RE: PZ# 24-12000026 KAJA Truck & Fleet Wash ([484234500010](#); [484234500020](#))

**URBAN FORESTRY comment 10** states, "Provide, note and clarify the required Type B Buffer on the east side, C Perimeter Buffers on the South, West and North sides as per 155.5203.F.3. and provide a cross section detail per side."

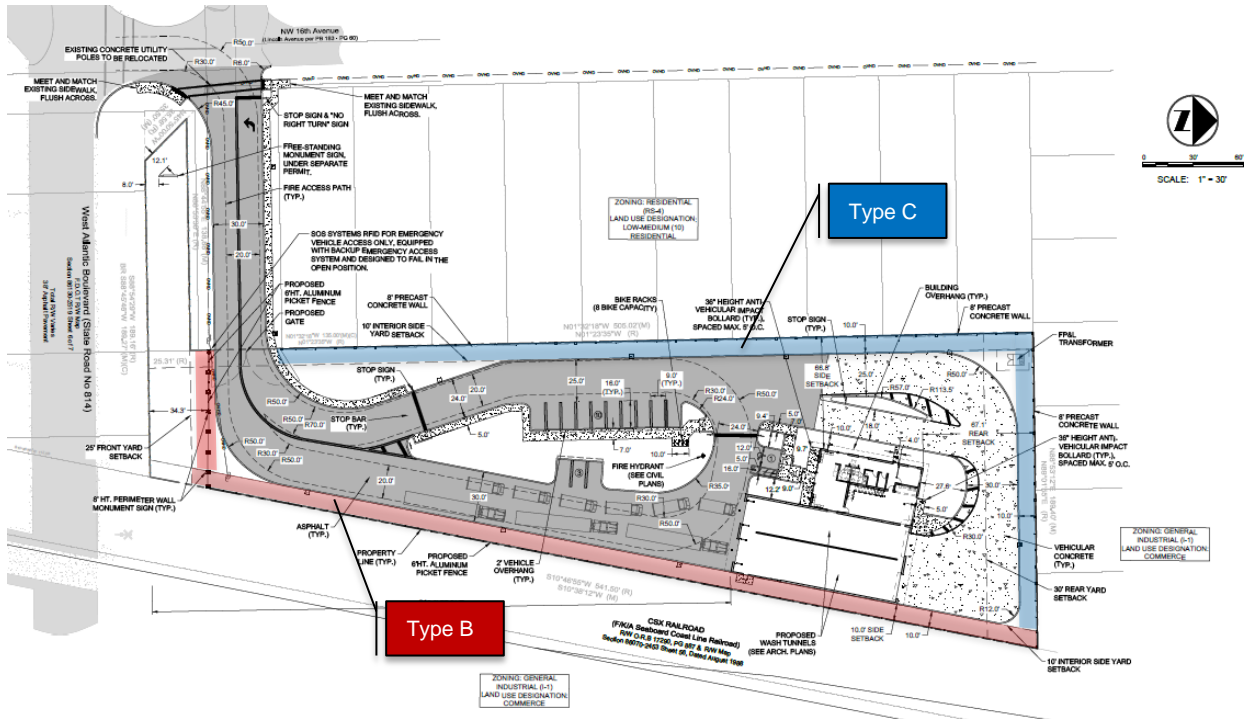
As shown below, the property abuts residential use to the west and north where a Type C buffer is required per Table 155.5203.F.3. The car wash use is required to provide a Type B Buffer along all perimeters, unless a Type C Buffer is required as mentioned, in accordance with code sections 155.4219.A.1.b and 155.4219.H.3.e. For the safety and privacy of the residential properties, we request all buffer landscaping to be installed inside of the wall, rather than placing the wall in the middle of the 10 foot-buffer. If a wall is placed in the middle of the buffer, maintenance of the landscaping and wall will be necessary, thereby possibly facilitating a maintenance worker to trespass onto residential private property. If the residential properties include a fence or wall on their private property, an additional wall will create an "alley" of unmaintained area that invites trespassing and possibly illegal activities. Providing the fence in the middle of the east buffer would put a maintenance worker near the railroad tracks which creates an unsafe condition for the maintenance worker.

As previously discussed with BSO Deputy Anthony Russo, the east buffer should have some visibility into the site for law enforcement monitoring, which is why we propose an open picket-style fence rather than a solid fence along the east. The south buffer will include 2 barriers-- a solid wall in one portion to screen the service bay entrance, and the open picket-style fence on the other portion to provide law enforcement visibility. This buffer wall will be set back more than 30 feet from the property line.

Buffer	Barrier Material	Barrier Location
East Type B	Open aluminum picket fence, rather than solid fence	Exterior boundary of buffer, rather than middle
South Type B	Mix of solid concrete wall & open aluminum picket, rather than fully solid barrier	Middle, no modification requested
North Type C	Solid, no modification requested	Exterior boundary of buffer, rather than middle
West Type C	Solid, no modification requested	Exterior boundary of buffer, rather than middle
